ADDENDUM NO. 1

Date: March 28, 2017

**Project: Irrigation Improvements & Outdoor Learning Area
at A.M. Winn K-8 School**

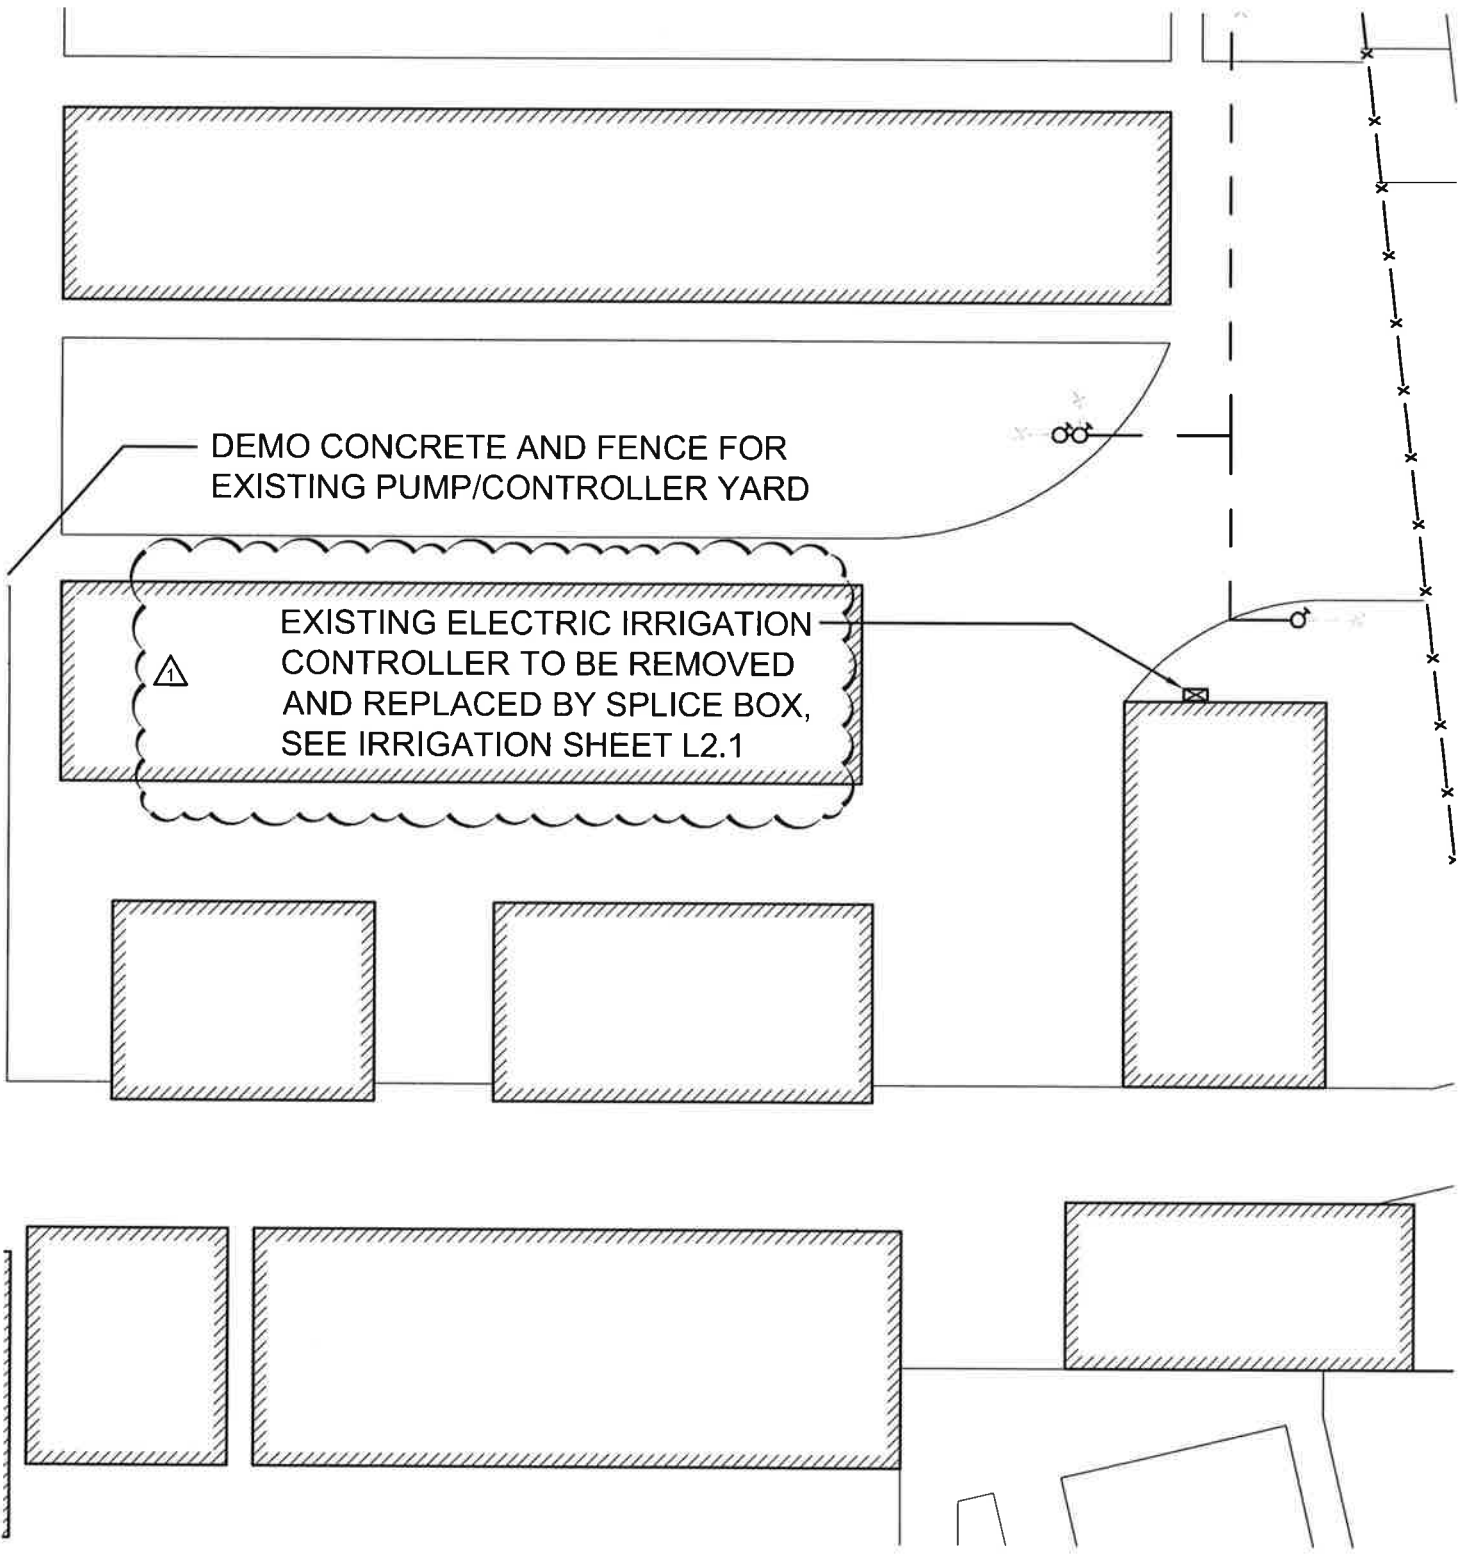
- a. Tree demolition can be removed from the scope. The school district has already removed them and ground the stump.
- b. Existing irrigation controller on portable that is to be removed is to have its control valve wires extended back to the new controller. See AD1-1.

REF. DWG.	L2.1
PROJECT NO.	16055
SHEET	AD1-2

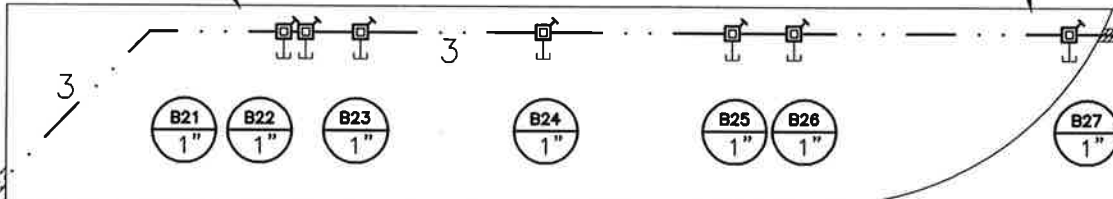
- a. Existing irrigation controller wires are to be spliced in a new valve box where they enter the ground next to the portable and extended to the nearby mainline and ran in the same trench back to the new controller. Wires to be connected to controller B, and to start at station 35. See AD1-2.

ELECTRICAL WIRES FROM DEMOLISHED IRRIGATION CONTROLLER TO BE PLACED IN NEW SPLICE BOX AND CONNECTED TO NEAREST NEW IRRIGATION MAINLINE
